Re: FTAA-2508-1096 Response to Minute 4 Expert Conferencing (Waitākere District Court – New Courthouse Project)

This memorandum provides a preliminary response to the matters to be discussed during expert conferencing outlined in Appendix 1 of Minute 4 received from the Waitākere District Court – New Courthouse Project Expert Panel on 17 February 2026.

Figure 1: Flood Velocity Map for indicative 'as-lodged scheme'

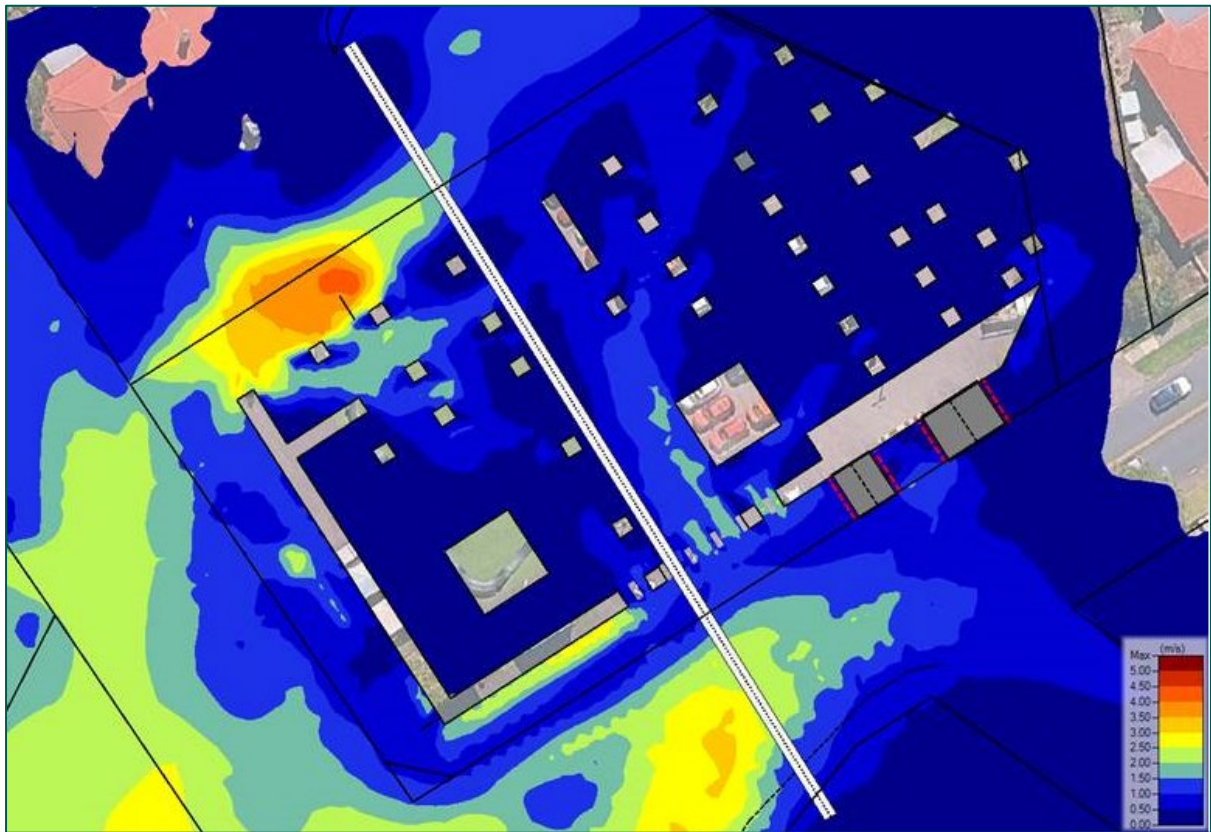
(4)	<p>With respect to the site layout, as per the Architects as-lodged and alternative layouts, there are areas where car parking and infrastructure is at ground level.</p> <p>(a) Noting that assessments to date have focussed on the safety of affected persons, what assessment has been undertaken for the safety of this car parking and infrastructure during the likelihood of flooding?</p>	<p>The design treats the ground level car park as a “sacrificial” flood conveyance area (the void).</p> <ul style="list-style-type: none"> Critical Infrastructure: Critical services (including switchboards, communications and detention tanks) are not located at ground level within the flood conveyance area. Finished Floor Levels are set at a minimum 8.58 m RL, providing greater than 300 mm freeboard, which separates critical infrastructure from flood hazard. Vehicles: Vehicles parked at ground level during a 1% AEP event are acknowledged to be at risk. However, the FEMP provides an estimated 10 to 12-hour warning window before site access becomes constrained, with Edmonton Road overtopping modelled at approximately 10 hours 25 minutes. Risk Management: Vehicle risk is managed through the FEMP early warning framework and signage rather than physical exclusion. This is considered acceptable given the car park functions as an overland flow path during major events only.
